## Fort Lauderdale Police Headquarters

WJE Peer Review, Phase 1 - North Elevation Evaluation

December 31, 2024  
WJE No. 2024.4855.0

### WJE Peer Review, Phase 1 - North Elevation Evaluation

Figure 13. Detail 6 from Sheet HQ-S5-1-03 dated May 24, 2024, showing section through column enlargement rectification for third story columns at gridlines H-2 and J-2.

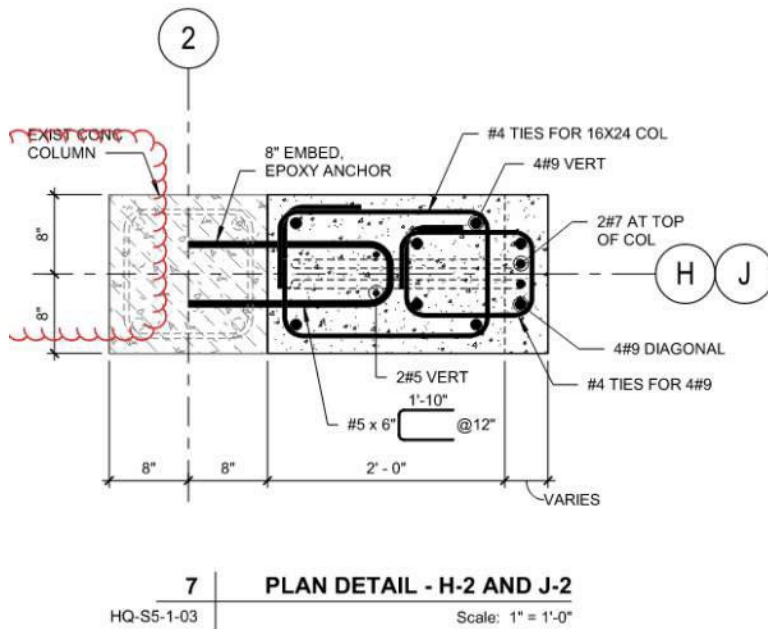
The column enlargement and corbel at the top of the enlarged column are connected to the original column with "U"-shaped No. 5 bar stirrups at 12 inches on center (see Figure 12 and Figure 13). While this distributed connection "stitches" the two columns together, it is our opinion that these "U"-shaped stirrups do not sufficiently resolve the horizontal force that is developed as a result of the inclined "strut" in the corbel. To sufficiently resolve the horizontal force, a tie that spans from the north side of the corbel to the south side of the original column is appropriate. Lakdas also suggested such a tie in their report (Figure 87). This tie should be designed for the horizontal component of the maximum diagonal strut force that is determined through staged-construction analysis. Long-term load-transfer effects due to creep should be considered in the design.

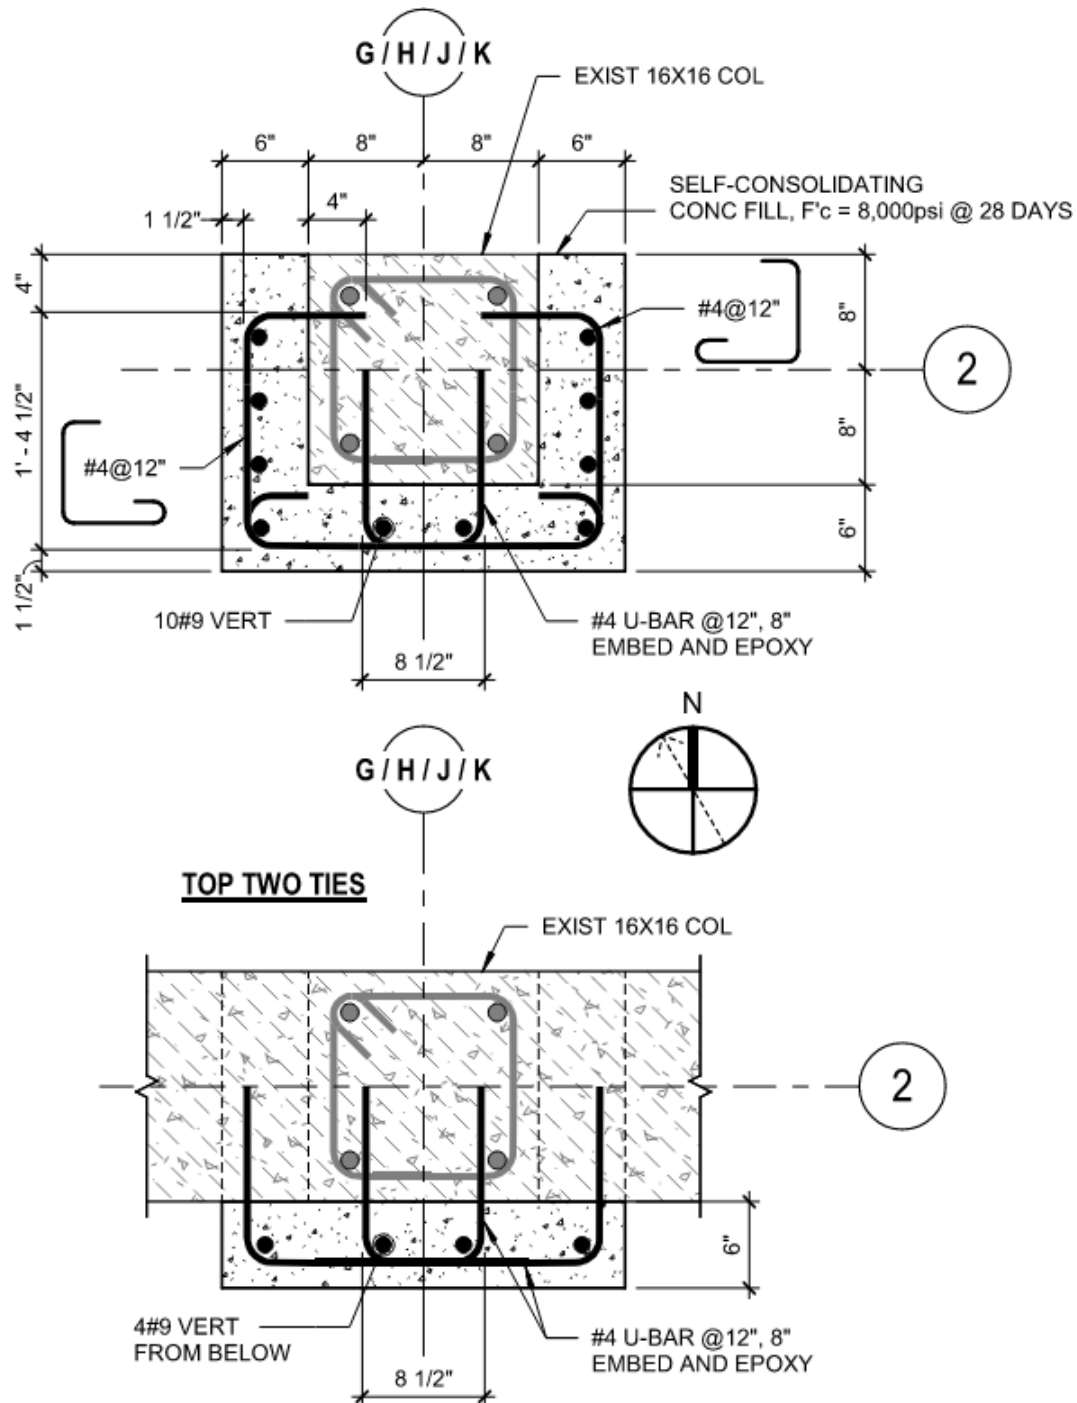
That said, we have some reservations about how the column jackets will be implemented. Currently, the ties for the column jacket (Figure 18), have their termination on the northern side of the column, embedded 4 inches into the column using epoxy adhesive. Terminating the tie in this manner will not

provide a closed tie. Closed ties will provide a more reliable means of restraining and bracing the flanges of the column bracket and will also serve to provide additional confinement to the original column. We recommend that the tie detail be modified such that a closed tie can be provided. One possible option to achieve a closed tie is shown conceptually in Figure 85.

Figure 79. Conceptual rectification for partial re-grouting of base of column enlargement

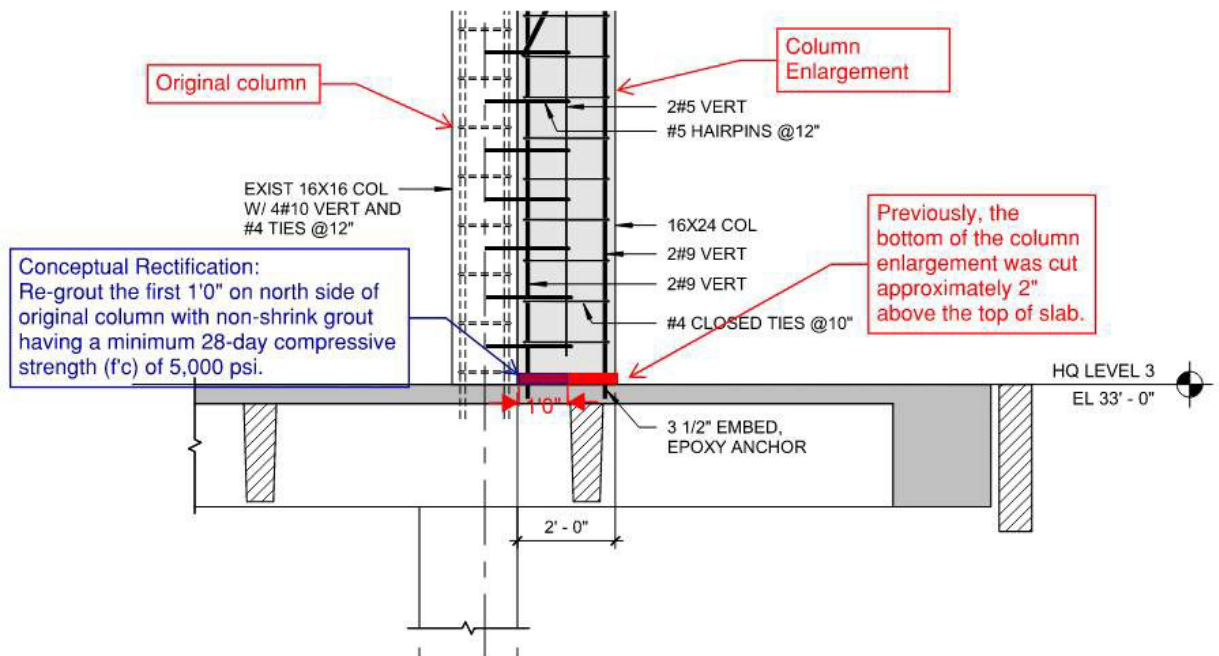
- This result is due to the condition at the base of the column where the column enlargement was demolished in combination with the biaxial bending in the column. If 12 inches of the column enlargement are grouted (see Figure 79) with non-shrink grout having a minimum 28-day compressive strength of 5,000 psi, then the column would be code-compliant for strength for axial plus biaxial bending.

must be resisted by the original column. We determined that once the enlargement was added and then the lower portion removed, the remaining original column cross-section is no longer code-compliant for axial plus biaxial bending due to the cut but could be brought back into compliance if 12 inches of the base of the column are regouted (see Figure 79).

Figure 82. Calculations of cantilever beam shear capacity at gridlines H-2 and J-2 by SEOR (from File 2024-04-25\_CALC\_HQ Roof Cantilever Field Fix at North Elevation.pdf) showing assumption of including shear friction of bars in bottom side (compression side) of the beam.

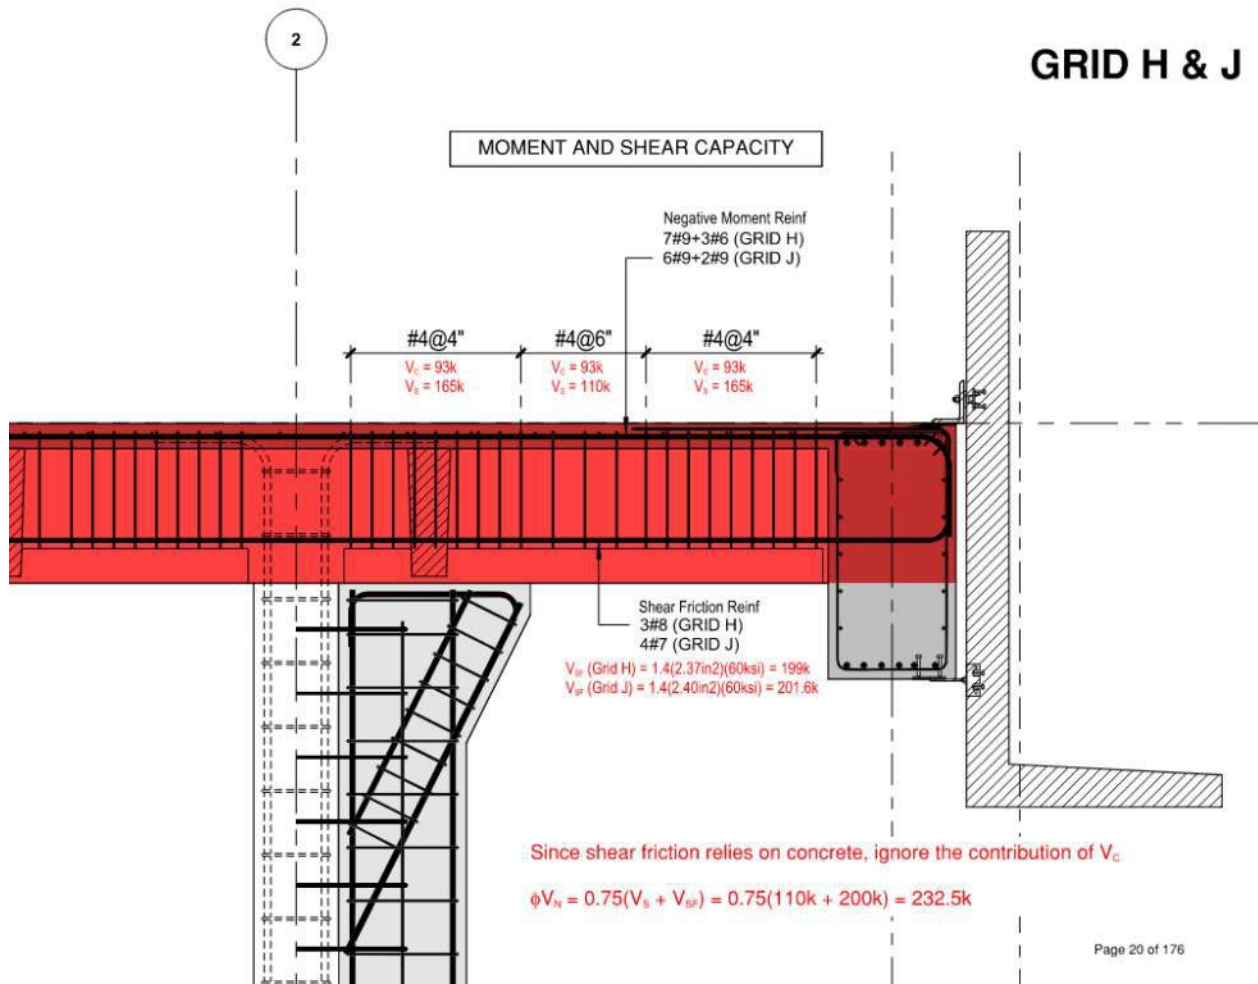
beam stirrups acting in a classical strut and tie shear resisting mechanism plus shear friction resistance that relies on longitudinal steel on the bottom side of the beam just above the precast soffit (Figure 82). However, in our understanding of the ACI provisions for beam shear and our experience<sup>4</sup>, combining shear friction resistance with classical strut and tie resistance to calculate the total sectional shear capacity of any beam is neither appropriate from a mechanics perspective nor permitted by ACI.

Figure 83. Conceptual solution for strengthening of cantilever roof beams

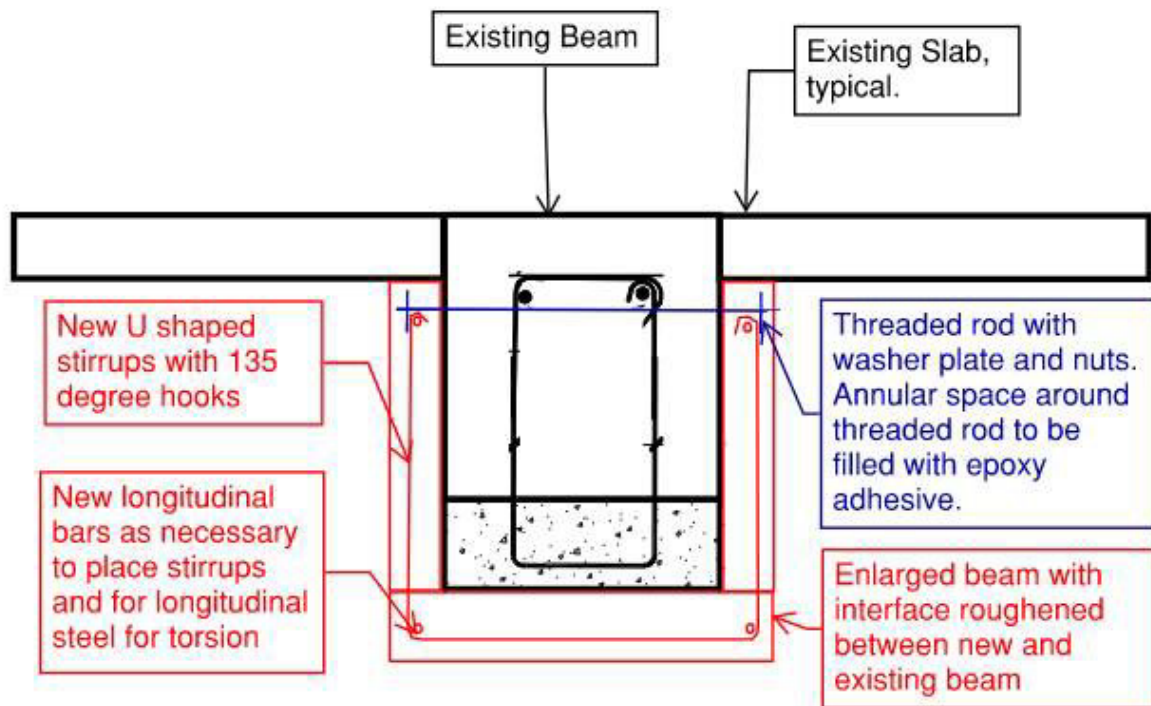
In our opinion the beam sections north of the column enlargement (i.e., along gridlines H-2 and J-2), need to be strengthened. Strengthening could be accomplished through the addition of a beam jacket with closed stirrups (e.g. Figure 83).
